PRESIDIO HEIGHTS MDP / PUD PLAN
 MASTER DEVELOPMENT PLAN / PLANNED UNIT DEVELOPMENT

Re: Presidio Heights

MDP # 003-07

The City Staff Development Review Committee has reviewed Presidio Heights Master Development Plan **M.D.P. # 003-07**. Please find enclosed a signed copy for your files. Your plan was approved for acceptance; however please note the following conditions:

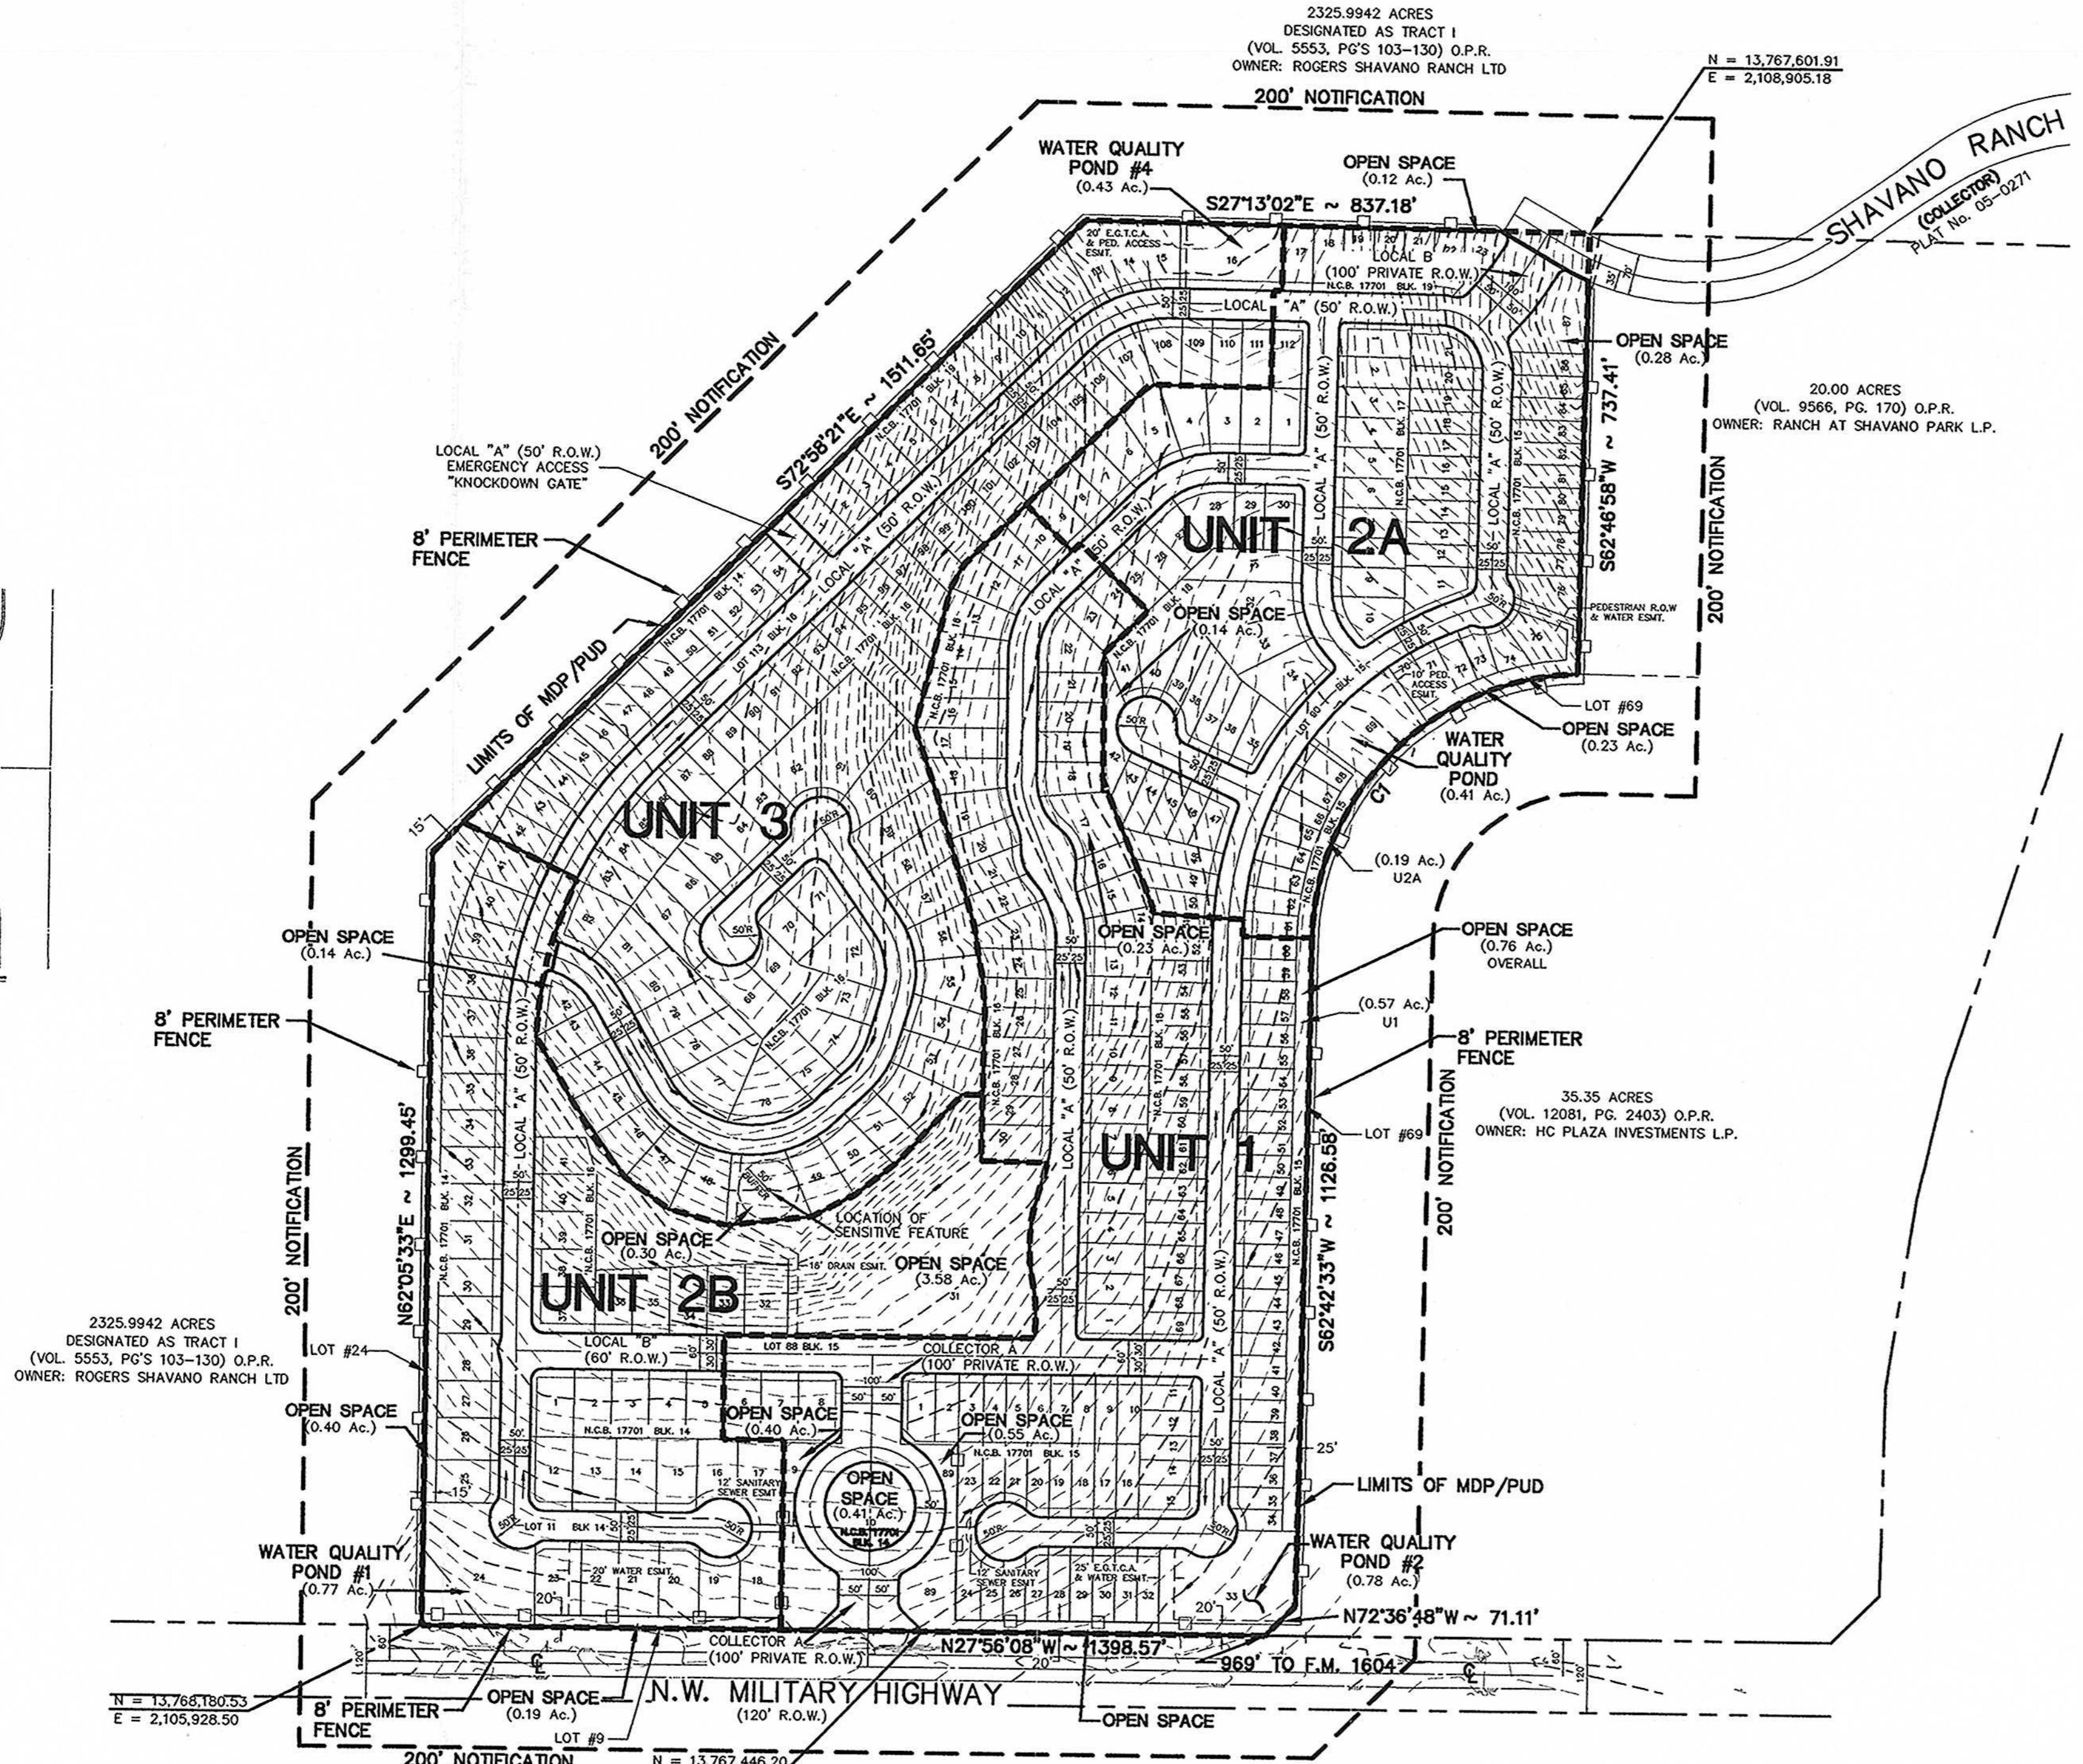
In consideration of public safety and convenience, excessive grades by reason of topography should be avoided in street layouts and arrangements. Any access and R.O.W. issues along state facilities will need to be resolved with the **Texas Department of Transportation (TXDOT)**. For information about these requirements you can contact TXDOT at 615-5814.

- All roadways shall conform to UDC 35-506(C)(1), Table 506-1: Functional Classification System Description.
- All access driveways shall comply with UDC 35-506(r) Access and Driveways.
- All access driveways shall provide clear sight distance on all existing and proposed roadways in order to provide adequate obstruction free viewing distances for approaching traffic. All signage, landscaping, and improvements shall be selected and located so as to not block these clear sight distances areas.
- The developer shall be responsible for providing right-turn deceleration lanes with storage lengths and bay taper in all the driveway access point approved by TXDOT as it relates to the submitted TIA traffic counts, Unified Development Code (UDC) – 35-502 (a)(7), subsection C.

proposed development. Reduced number of driveways and cross access is encouraged in order to provide safe and efficient movement of traffic to and from, within and past, the proposed development, while minimizing the impact to non-site trips.

- The parkland provided shall be shown as “Park” or “Open Space” on a plat; UDC section 35-503(e) *Designation of Parkland*.
- The parkland provided shall be dedicated to the Homeowners Association.
- The instruments creating the Homeowners Association shall be provided by the second application for plat approval; UDC section 35-503(e) *Designation of Parkland*
- Parkland dedication shall be platted by the second phase of development; UDC section 35-503(f) *Development Phasing*.
- All amenities provided shall comply with standards and specification found in UDC section 35-503(h) *Credit for Park Facilities* and Table 503-4 if any credit is to be awarded.

- 2003 Tree Preservation ordinance standards per UDC Section 35-523 – a Master Tree Permit has already been approved for this project (AP 1312940) using the Tree Canopy Delineation method (35% preservation required).

- This development will be allowed to pay the Storm Water Management Participation Fee. The provided Storm Water Management Plan shows the existing culverts on Military Hwy to be “safe” under ultimate conditions. Therefore, there is no need to upgrade the culverts as proposed and the request to provide offsite mitigation in lieu of paying the Storm Water Management Fee has been denied.

- 100 year Flood Plain Shown and Buffering (If applicable)
- Significant Recharge Features and Buffering (If applicable)
- Category Letter for All Site Specific Plats (If Category 2 or 3, an Aquifer Protection Plan is required (If applicable)
- According to the Aquifer Protection Ordinance No. 81491, section 34-913 buffering may be required. The sensitive feature found on property has been noted and SAWS is in agreement of the 4 acre buffer provided by the developer. Any existing well(s) found on

- Additionally, a Water Pollution Abatement Plan or Contributing Zone Plan must be submitted to and approved by the Texas Commission on Environmental Quality (TCEQ) prior to construction.

- The Ranch at Shavano Park Unit 2 plat # 050271 provides secondary access to this development, which needs to be recorded, constructed, and accepted by the City by or before the 125th lot is reached.
